ASHRAE® STANDARD

BACnet™ - A Data Communication Protocol for Building Automation and Control Networks

The purpose of this addendum is to add a number of independent substantive changes to the BACnet standard. These modifications are the result of change proposals made pursuant to ASHRAE continuous maintenance procedures and of deliberations within Standing Standard Project Committee 135. The changes and their rationale are summarized below.

20.1.2.11 Format of the BACnet-Confirmed-Request-PDU

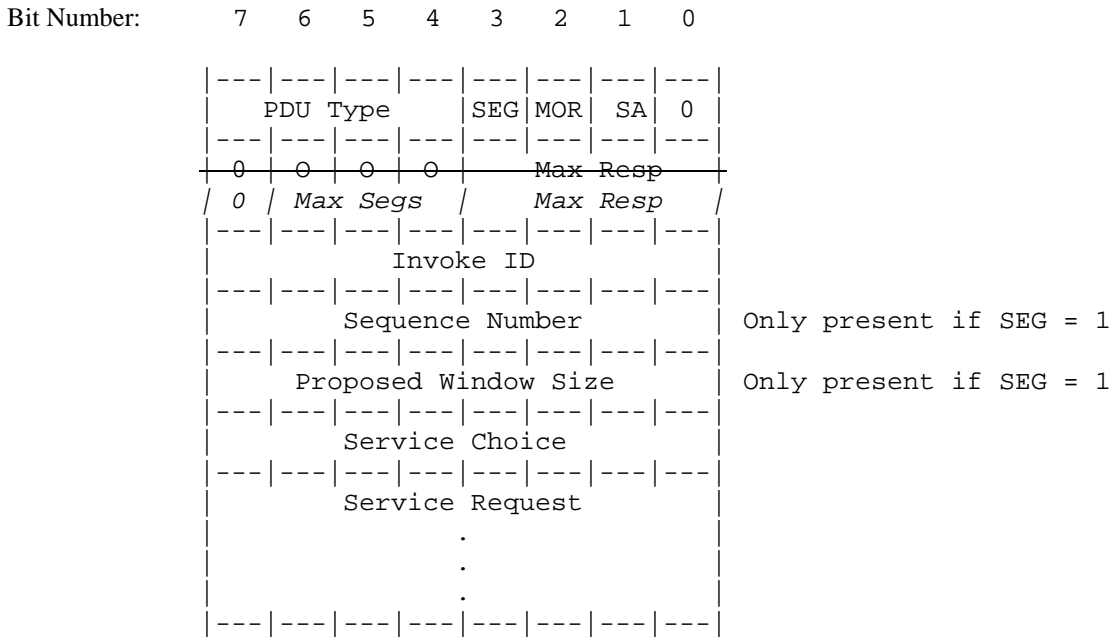
[Change 20.1.2.11, p. 325]

Bits shown in the diagram as '0' shall be set to zero. These bits are currently unused and are reserved by ASHRAE.

- PDU Type = 0 (BACnet-Confirmed-Service-Request-PDU)
- SEG = 0 (Unsegmented Request)
- = 1 (Segmented Request)
- MOR = 0 (No More Segments Follow)
- = 1 (More Segments Follow)
- SA = 0 (Segmented Response not accepted)
- = 1 (Segmented Response accepted)
- Max Segs = (0..7) (Number of response segments accepted per 20.1.2.4)
- Max Resp = (0..15) (Size of Maximum APDU accepted per 20.1.2.4 20.1.2.5)
- Invoke ID = (0..255)
- Sequence Number = (0..255) Only present if SEG = 1
- Proposed Window Size = (1..127) Only present if SEG = 1
- Service Choice = BACnetConfirmedServiceChoice
- Service Request = Variable Encoding per 20.2.
